TRANS/WP.29/GRSP/2000/3/Rev.1
20 February 2004

PROPOSAL FOR DRAFT AMENDMENTS TO REGULATION No. 44
(Child restraint systems)

Transmitted by the expert from Japan

"Annex 7 - Appendix 2-1
Curves of the trolley's acceleration as a function of time
Frontal impact

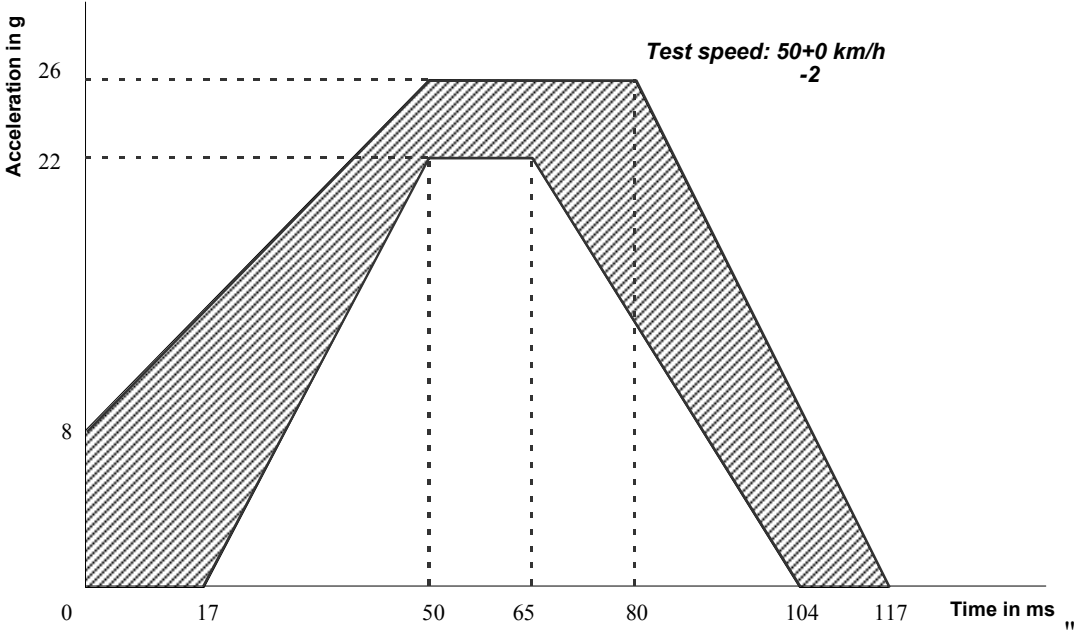
The trolley shall be so propelled that, during the test, its speed variation is [50 +0/-2 km/h] and its acceleration curve is within the hatched area of the appendix 2 of annex 7. Despite the fulfilment of the above requirements, the technical service can use a mass of trolley (equipped with its seat), as specified in paragraph 1 of Annex 6, superior to 380kg."

Insert a new Appendix 2-1., to read:

[Modification of corridor ($\pm 4g \pm 2g$ for acceleration device)]

The corridor shown in annex 7 appendix 2-1 to this regulation has smaller limits compared with the existing corridor of deceleration device.

The new corridor has a width of $\pm 2g$ from the centre line while the existing corridor has one of $\pm 4g$. Timing of inflection point and slope are set the same in both corridors.

"Annex 7 - Appendix 2-2
Curves of the trolley's acceleration as a function of time
Rear impact

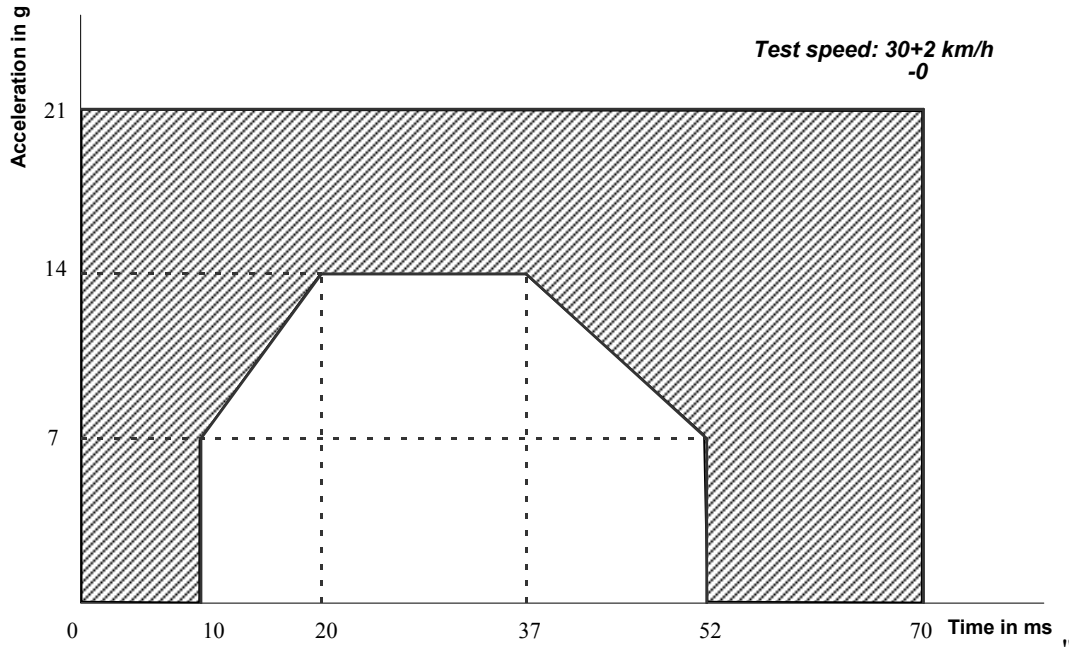
Insert a new Appendix 2-2., to read:
